1969 Corvette: Service News: 1969 Corvette Steering Column - Control Lock Tube Housing Cover Added

Source: Chevrolet Service News

Date: April 1969 - Volume 41 - Number 4

Fig. 44—Corvette Control Lock Tube Housing Cover

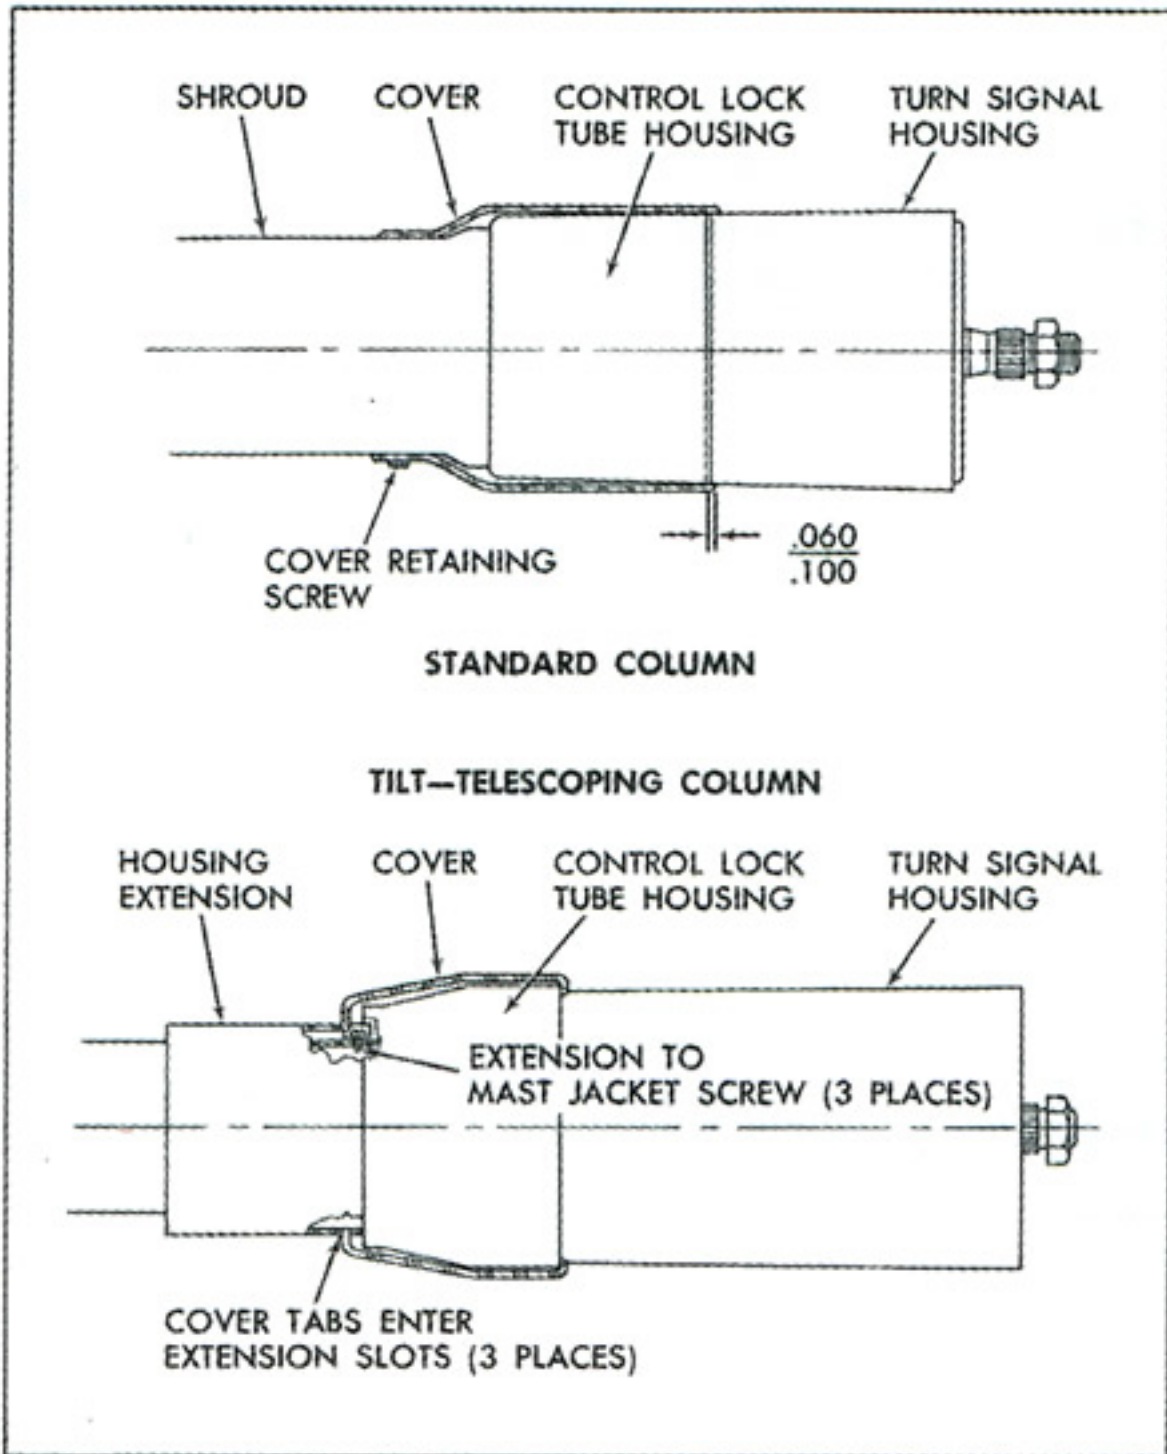
A control lock tube housing cover has recently been incorporated into the 1969 Corvette steering column, both standard and Tilt-Telescoping types, as shown in Figure 44. This cover is intended to prevent the lock tube housing from being rotated and subsequent damage to the control cable.

The following steps in the 1969 Passenger Car Chassis Service Manual should be revised:

On Page 9-14, Step 10 of the procedures for 'Disassembly - All Except Tilt and Tilt-Telescoping Columns; should appear as follows:

10. Remove the gearshift lever housing and shroud from the jacket assembly (transmission control lock tube housing and shroud on floor shift models).

Corvette - If either the shroud or housing cover are damaged, remove the retaining screw and slide the cover off the shroud.

On Page 9-17, Step 7 of the procedures for 'Assembly - All Except Tilt and Tilt-Telescoping' should appear as follows:

7. Install the shift tube lock plate and spring into the gearshift lever (or lock tube) housing and install the cover onto the shroud (Corvette). Install the housing and shroud assemblies onto the upper end of the mast jacket. Rotate the housing to be sure it is seated in the bearing.

On Page 9-21, Step 17 of the procedures for 'Disassembly - Tilt and Tilt-Telescoping Columns' should appear as follows:

17. *All Columns* - Remove the shift lever housing from the mast jacket (transmission control lock tube housing on floor shift models). Remove the shift lever spring by winding the spring up with pliers and pulling it out. on floor shift models, remove the spring plunger.

Tilt-Telescoping Columns - Pry the transmission control lock tube housing cover tabs out of the slots in the housing extension and remove the cover. Remove the three housing extension screws and remove the housing extension.

On Page 9-22, Step 2 of the procedures for 'Assembly - Tilt and Tilt-Telescoping Columns' should appear as follows:

2. *All Columns* - Install the shift lever spring into the housing by winding it up with pliers and pushing it into the housing. On floor shift models, install the plunger.

Tilt-Columns - Slide the gearshift lever housing onto the mast jacket.

Tilt-Telescoping Columns - Install the transmission control lock tube housing extension and torque the screws to **40 in. lbs** . Install the housing cover onto the extension. Install the housing onto the mast jacket assembly.
